Helping you fix it right the *first* time - every time

## S/M Fix: Evaporator Temp Sensor Test, '06–07 Civic

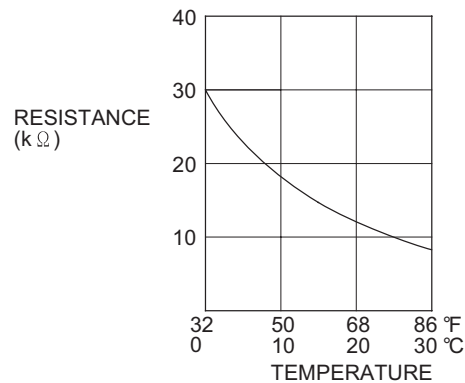
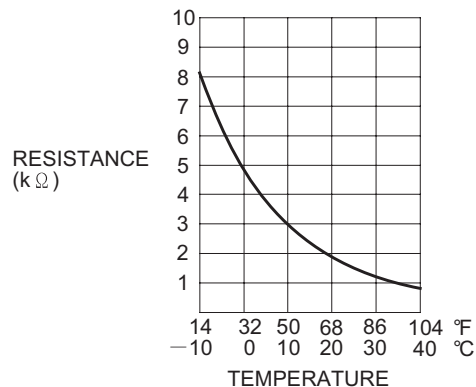
You need to do a bit of tweaking to step 4 of the Evaporator Temperature Sensor Test on page 21-76 of the '06–07 Civic S/M Volume 2. The evaporator temperature sensor for '07 Civic Coupes has changed and, along with it, its specified resistance values.

Cross out step 4 in your copies of the S/M, and use this version instead:

4. Compare the resistance readings with the specifications shown in the graph; the resistance should be within the specifications.

'06 2-door and 4-door models

'07 4-door model

'07 2-door model
